PETITION FOR ZONING VARIANCE TO THE ZONING COMMISSIONER OF BALTIMORE COUNTY:

Case No. 86-176-A

RE: Item No. 411 - Case No. 86-176-A
Petitioners - George Kosmakos, et al
Variance Petition

PARKING VARIANCE PLAT FOR
PROPOSED ADDITION TO KOSMARKOS INN
9811 YORK ROAD, COCKEYSVILLE, BALTO. CO. MD.

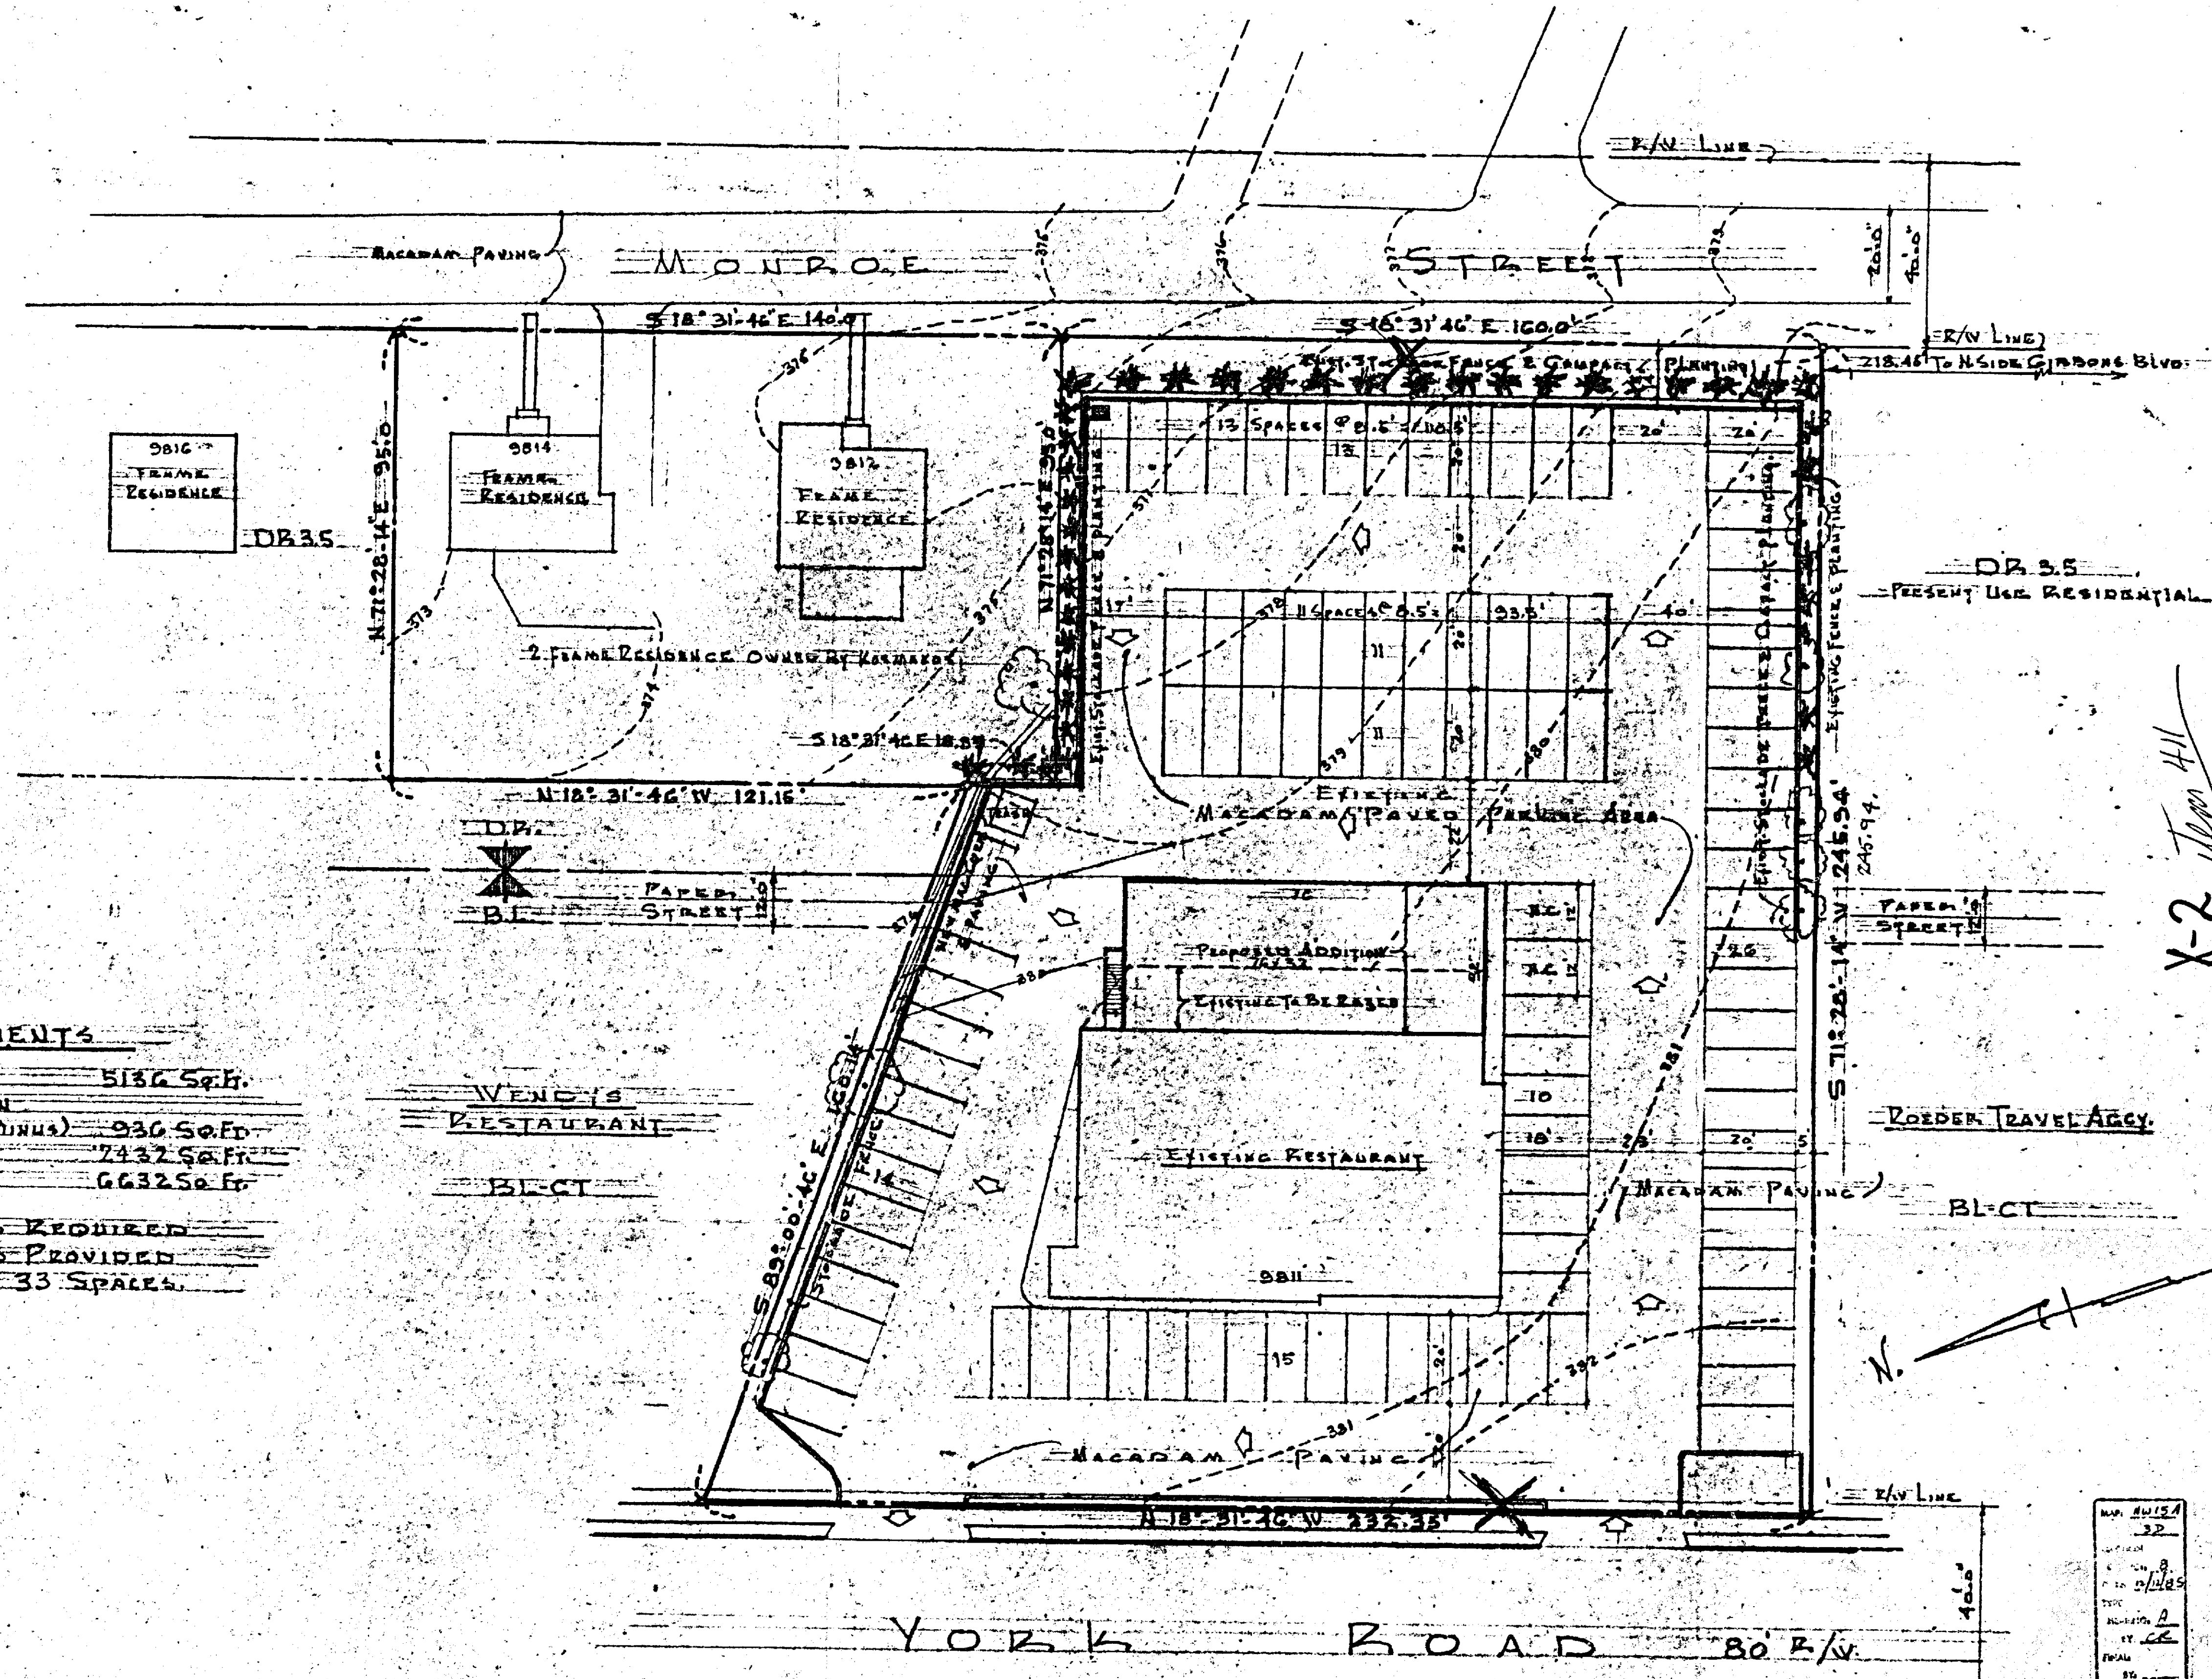
10. Comments: Revised plan is still two handicapped spaces short. Type of construction, required exits shall comply with the Code. Show curb cuts, ramps, etc. for handicapped.
